Best Wool Sweaters Ltd. (New Building)

Jarun, Konabari, Gazipur
(24.000421N, 90.323217E)
26 September 2023

Observations

Column layout plan

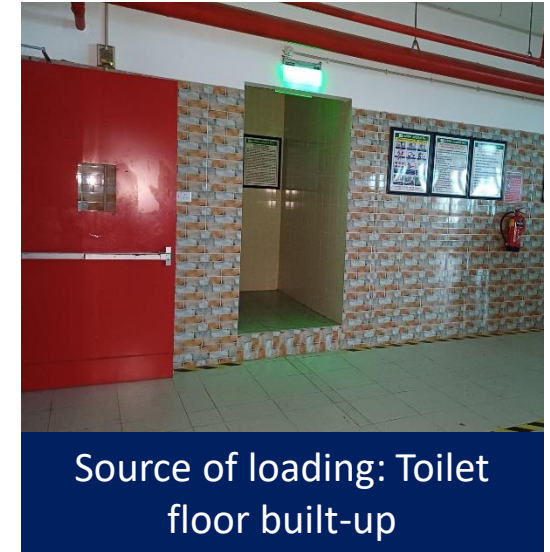
Stress in foundation exceed normal design limit

Cursory calculation indicates that the marked footing are overstressed based on live load (4kPa for typical floor, 6 kPa for storage area, 2 kPa for toilet, & 5 kPa for stair), dead load (including observed toilet built-up and wall load) and 156 kPa for foundation capacity. The source of loadings are storage floor and toilet built-up. Building engineer is required to carry out Detail Engineering Assessment (DEA) to review the design, loads and foundation stress based on material strength, and minimum floor live loads.

Source of loading: Toilet floor built-up

Lack of design document

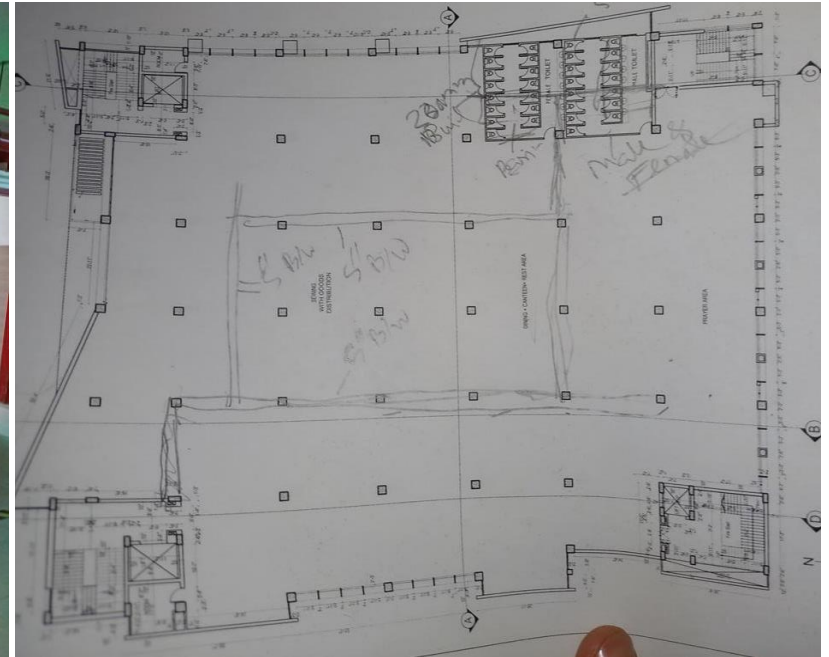
As per BNBC (part-6), every building or structures designed shall have its design documents in accordance with the provision of section 1.9.1. During inspection, no design report and load plan were found on-site. Building engineer is required to prepare a set of design documents (including load plan as per BNBC and design report based on material strength & software-based analysis) for the structure following BNBC (part-6, section 1.9.1).

Mismatch in wall and toilet layout in 6th floor

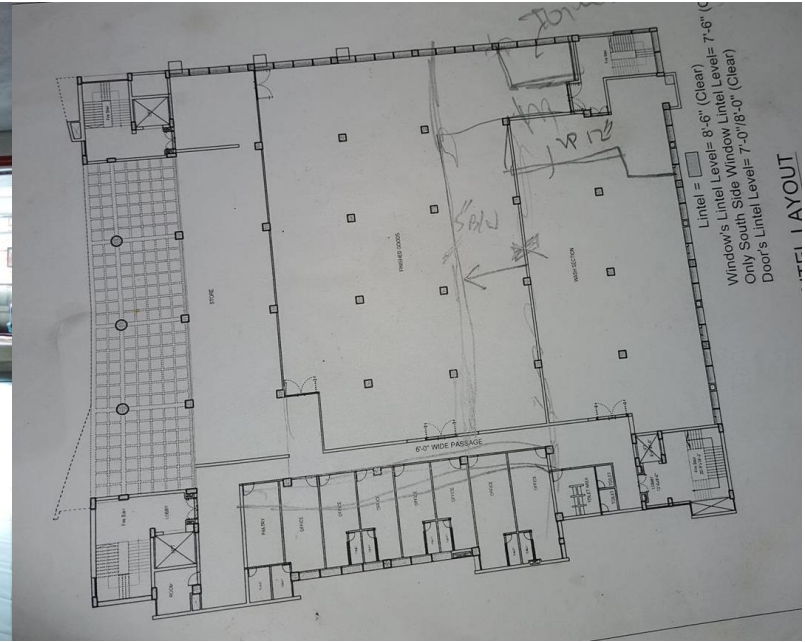
Discrepancy in as built drawing

Mismatch in wall layout and floor built-up

During inspection, mismatch was observed regarding brick wall layout, toilet layout and floor built up layout. Building engineer is required to update the as-built drawing as per site condition and consider the load from wall and floor built-up in design and design report.
